Subject: **MOMENTARY HORIZONTAL NOISE**

Model: **PVM-8040, PVM-8041Q, PVM-8044Q**
PVM-8043MD, BVM-8044QD

Figure 1

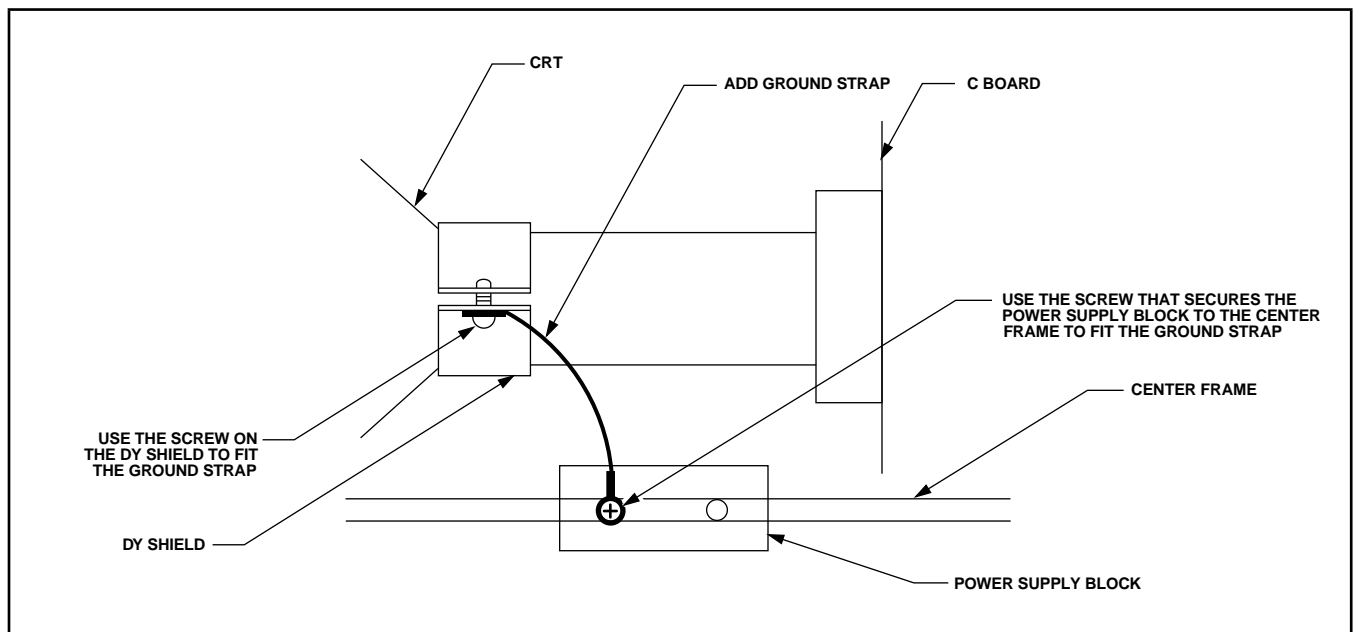
Static electricity on the DY shield may cause horizontal noise to be displayed. To correct this condition perform the following modification.

Fit a ground strap between the DY shield and the center frame as shown in Figure 1.
